March 2013, brand-new
“walkway” on Chamberlain Rd.

Traffic Safety Proposal

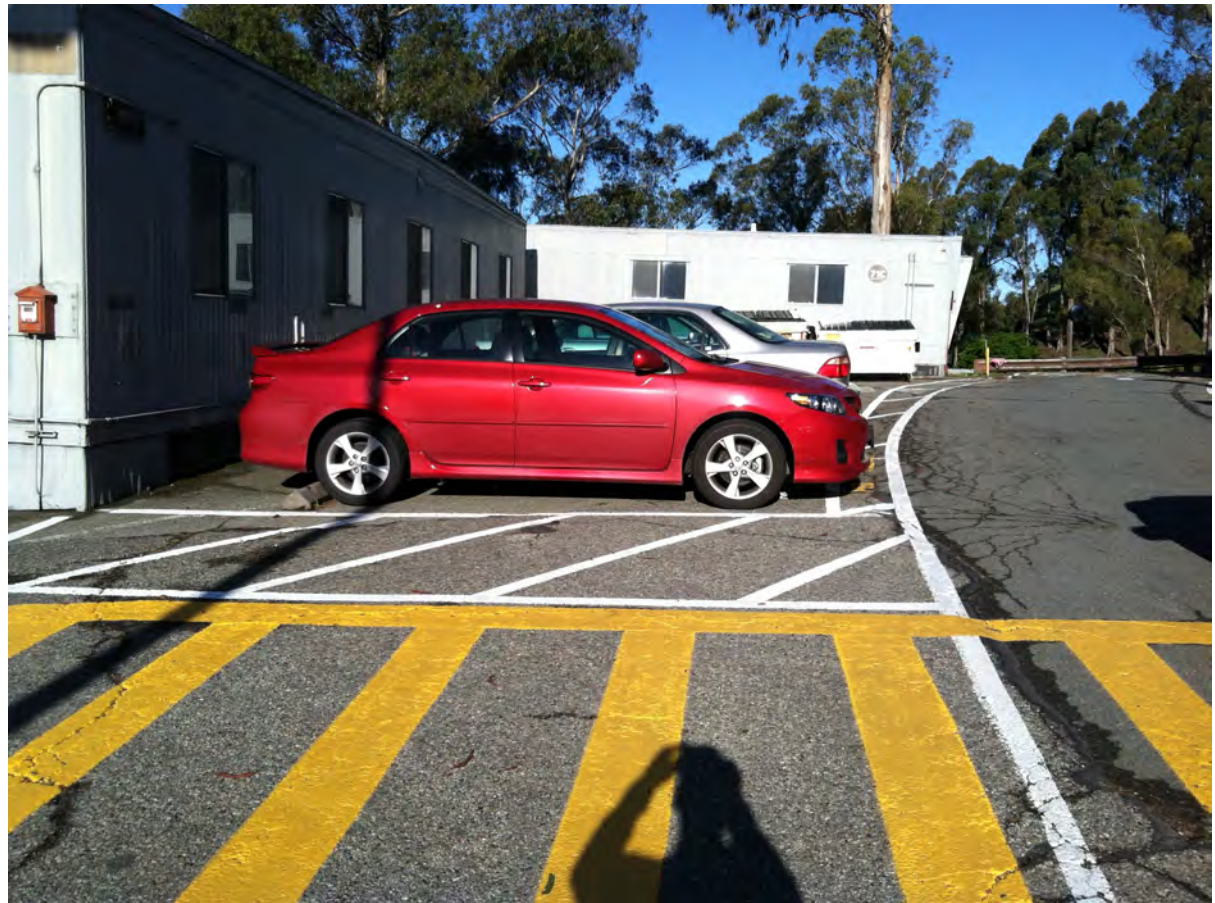
There is no buffer or curb
between “walkway” and
roadway. Width of the new
“walkway” is 21 inches, much
less than walkway widths
referred to in traffic manuals.

Does this “walkway” help ensure pedestrian safety?

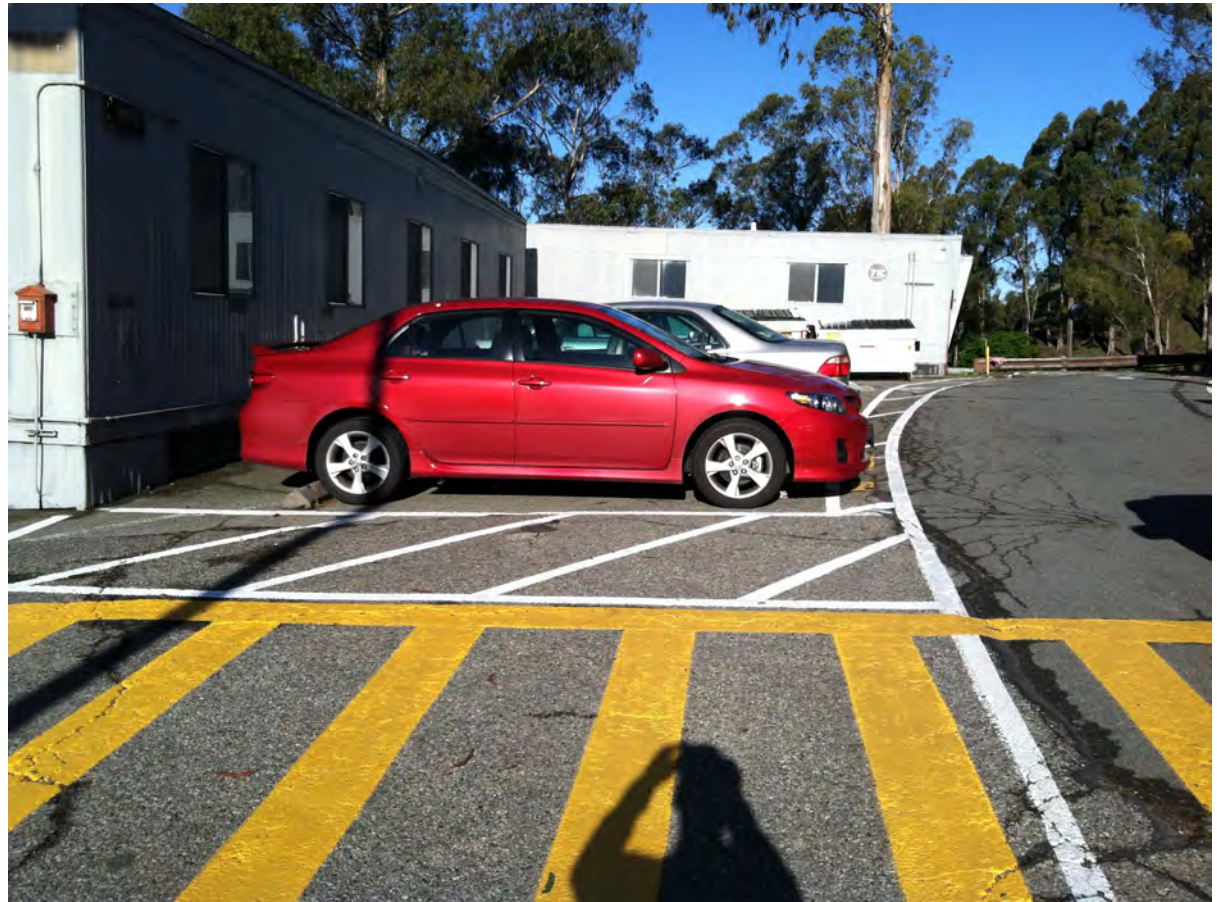
The little red Toyota Corolla is backed up as far into the space as possible, rear wheels at curb, yet it blocks most of the new “walkway”:

Even a little car cannot *not* block the “walkway”.

How much room do we need for a walkway?

In this situation, many pedestrians will end up walking in the street.
